APPEAL SUMMARY

Appeal ID: 22157

Project Address: 5510 N Denver Ave

RECONSIDERATION OF APPEAL ID:
22001

L1 ARCHITECTURAL PLAN - STEEL POST MARKUP

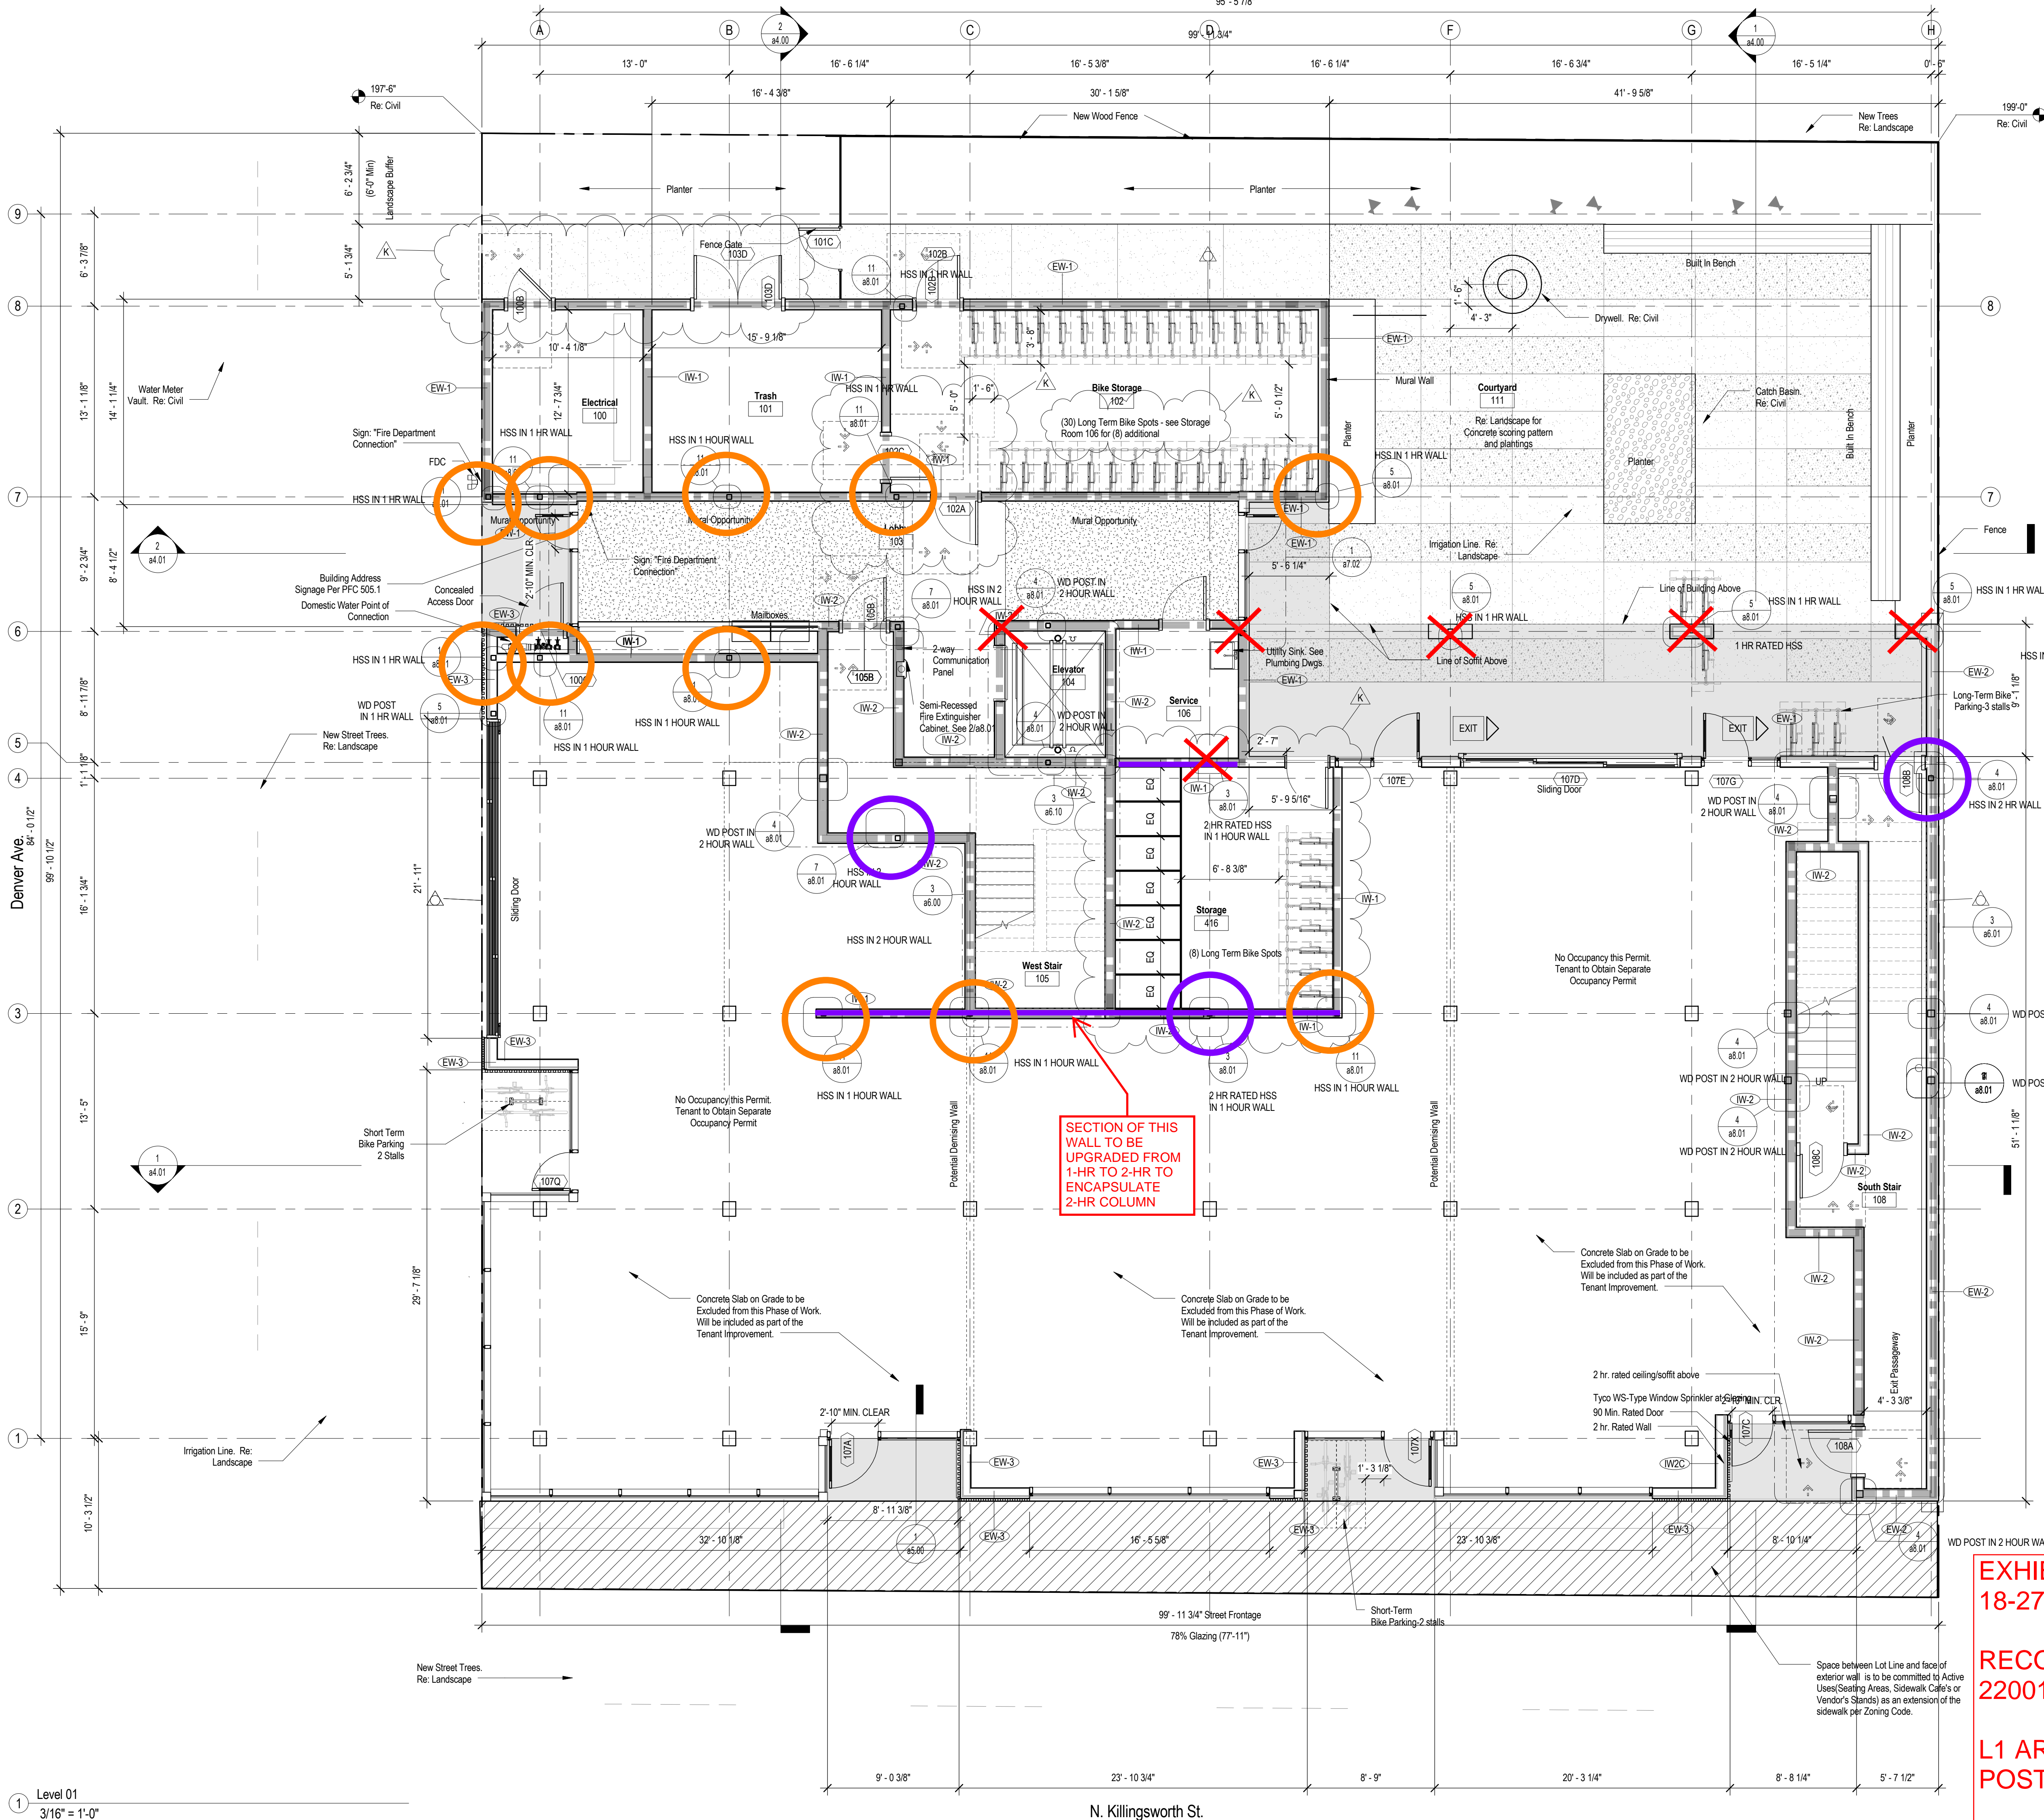
Exhibit 3 shows each steel post marked up to show the rating requirement within the wall. A number of posts cannot meet the requirements to encapsulate the base plate, and these posts are indicated in the markup.

STEEL POST WITHIN 1-HR FIRE-RATED WALL ASSEMBLY:

GLULAM BEAM ABOVE:
12/ a8.01 (head) - EXHIBIT 5
SSK-001 (base) - EXHIBIT 7
NO GLULAM BEAM ABOVE:
13/ a8.01 (head) - EXHIBIT 5
SSK-001 (base) - EXHIBIT 7

STEEL POST WITHIN 2-HR FIRE-RATED WALL ASSEMBLY:

GLULAM BEAM ABOVE:
12/ a8.01 (head) - EXHIBIT 5
SSK-001 (base) - EXHIBIT 7
NO GLULAM BEAM ABOVE:
13/ a8.01 (head) - EXHIBIT 5
SSK-001 (base) - EXHIBIT 7

THESE POSTS WILL NEED TO BE ENCASED INDIVIDUALLY AND DO NOT FORM PART OF THIS APPEAL

REFERENCE DETAIL 6/a8.01 ON EXHIBIT 5 FOR POST WITHIN 1-HR WALL

REFERENCE DETAIL 2/a8.01 ON EXHIBIT 5 FOR POST WITHIN 2-HR WALL

L1 STRUCTURAL PLAN - STEEL POST
MARKUP

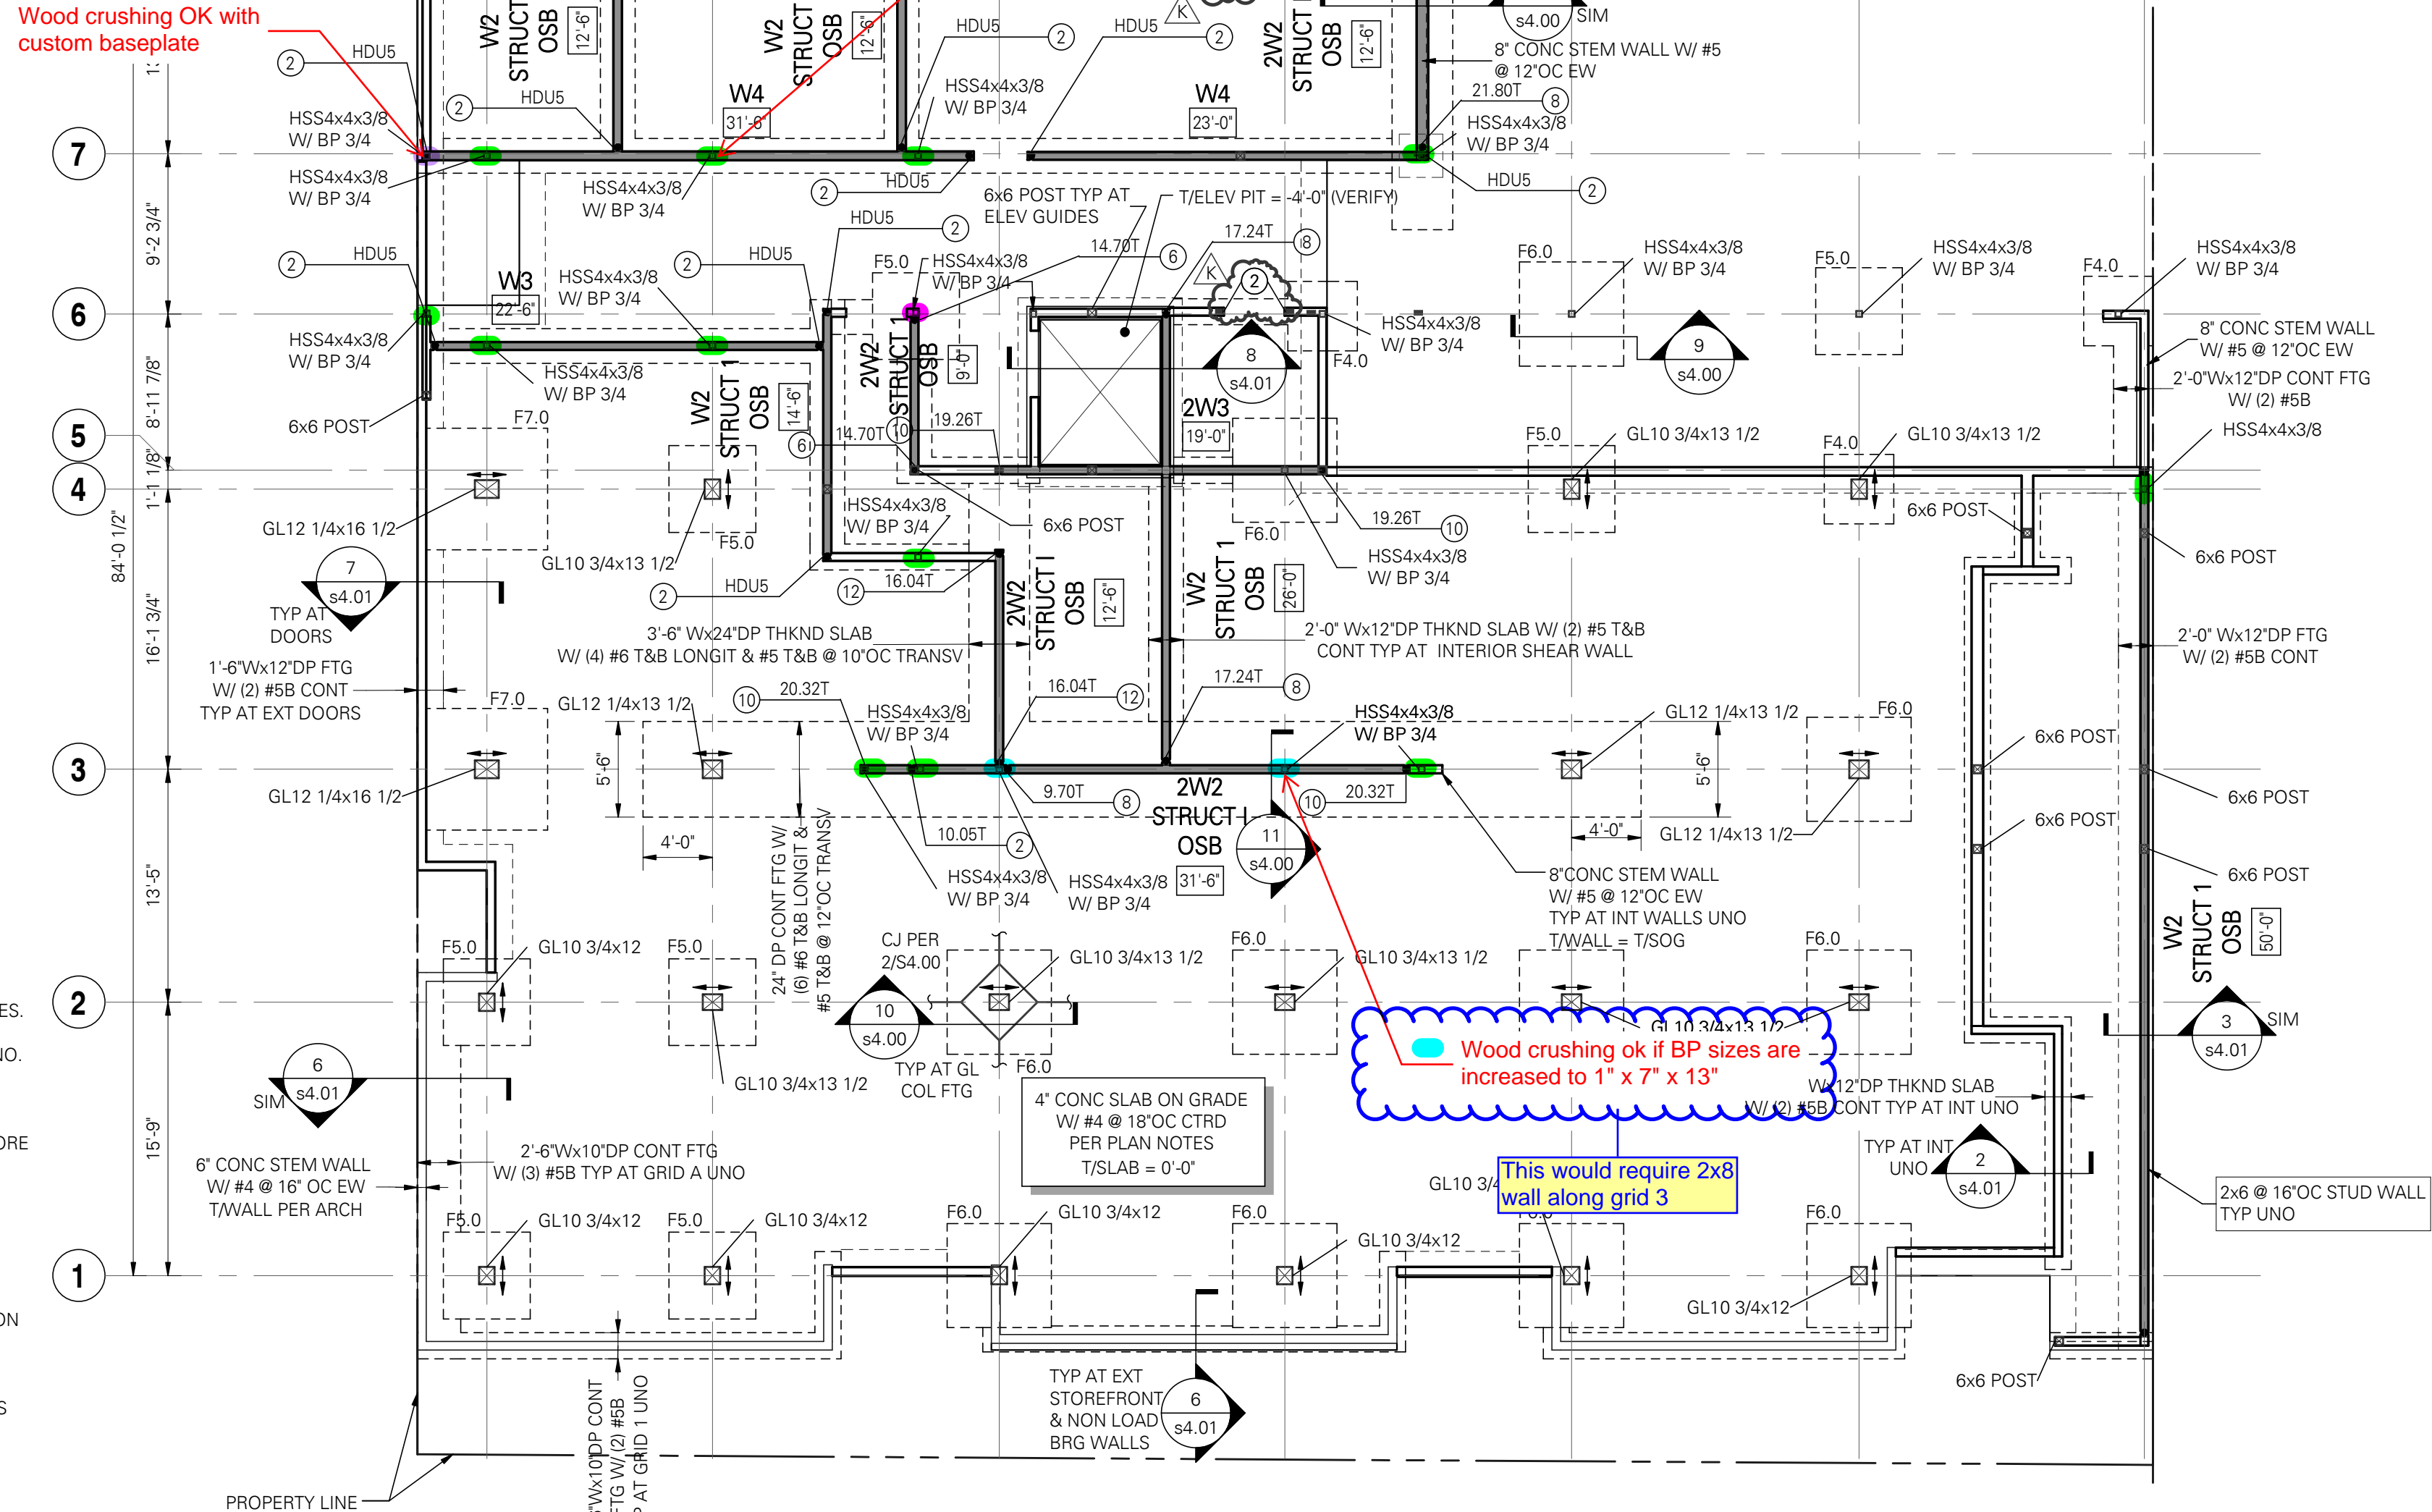
Exhibit 4 shows the structural plan with markups indicating the base plate revisions required to withstand wood crushing for the wood bottom plate. Kevin White, the structural reviewer, has reviewed the detail and indicated that the concept is feasible provided a revision to the permitted drawings be submitted and approved; the structural calculations submitted with this revision will address the sizing and anchorage of the revised steel base plates, and crushing of the wood sill plate for all updated/ revised conditions.

Wood crushing OK with custom baseplate

REFER TO INDIVIDUAL NOTES FOR NEW BASE-PLATE SIZES.

A FULL REVISED BASE PLATE SCHEDULE WILL BE PROVIDED WITH THE PERMIT REVISION.
